Docket Item # 6 and #7
BAR CASE #2005-0234
BAR CASE #2005-0235

BAR Meeting
November 2, 2005

ISSUE: Addition, New Garage, and Alterations & Waiver of
Rooftop HVAC Screening Requirement

LOCATION: 607 South Pitt Street

Figure 1 Proposed east elevation

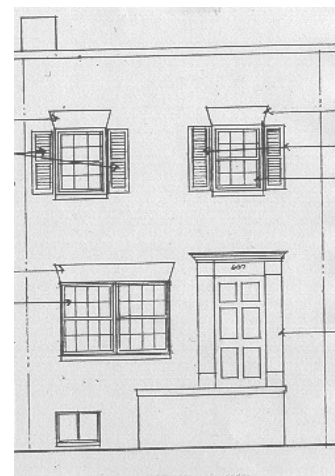
The current windows will be replaced on the front facade. The existing windows do not appear to be original and appear to be replacement windows. The drawings submitted by the Petitioner state that the new windows will be wood, double-glazed, simulated divided light with spacer bar, 7/8" muntin profile, eight-over-eight light configuration on the first floor, and six-over-six light configuration on the second floor, with the windows manufactured

by Kolbe and Kolbe. However, Staff expressed concern to the Petitioner and to the Petitioner's architect over the use of double-glazed and simulated divided light instead of single-glazed and true divided light. The Petitioner has verbally agreed to use for the front facade replacement windows, wood, double-hung, single glazed, true divided light windows, with the appropriate light configuration, manufactured by Kolbe and Kolbe. The Petitioner will also use wood trim around the front door to replace the deteriorated wood door surround.

Staff recommends approval with the understanding that wood, double-hung, single glazed, true divided light windows are used as replacement windows on the front facade and the following conditions:

Figure 2 Proposed rear elevation

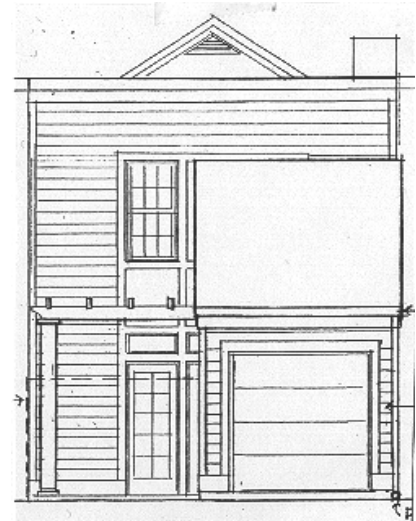
A two-story, rear addition is proposed for this property, with a depth of 20'6" and a width of 18'. The rear addition has a foot print of 369 square feet. The existing house has a footprint of 581.4 square feet. The proposed addition will result in the demolition of the existing rear wall. The new addition will be clad in smooth Hardi-plank with a 6" reveal and painted grey. All trim will be white. The side walls will be 8" CMU walls with cement parge to provide necessary firewalls. Three windows on the second floor of the addition will be wood, double-hung, simulated divided light with a 7/8" muntin profile, with a six-over-six light configuration, and manufactured by Kolbe and Kolbe. On the first floor, three swing-in, French-style doors, with transoms will provide access to the rear courtyard area. The doors are also manufactured by Kolbe and Kolbe. The addition will have through the wall aluminum scuppers, with downspouts attached to the exterior corner trim. A gabled skylight will be located on the roof of the new addition, largely screened from public view by the parapet of the roof. A fiberglass pergola will be attached to the new addition, supported by 10" round Doric columns.

Figure 3 North elevation of garage

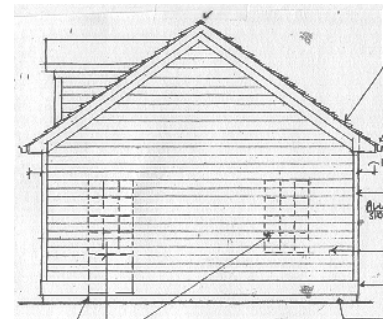
A new one car garage will be constructed within the existing rear courtyard area. The proposed garage will be 205 square feet. Originally, the Petitioner had proposed a two-bay garage, with a large dormer window on both the alley and courtyard elevations. The open-space requirements would not allow the two-bay garage as proposed. The Petitioner revised the proposed garage, reducing the size to one-bay and eliminated the dormer facing the alley, while keeping the dormer facing the main house, to provide light and access to storage within the garage. The dormer will not be largely visible from the public-right-of-way of the alley. The dormer's window will be a six-over-six, double-hung, window by Kolbe and Kolbe. The proposed garage will be sided with smooth Hardi-plank siding with a 6" reveal and the gable roof will have shingles. White aluminum gutters will be installed at the fascia, above the garage door openings. The Petitioner is proposing either two windows on the north wall, facing the open space, to match windows on the front facade or one window and one six-panel wood door. Staff would support either option. Wood, overhead garage doors are

proposed, for both the west and east elevations of the new garage.
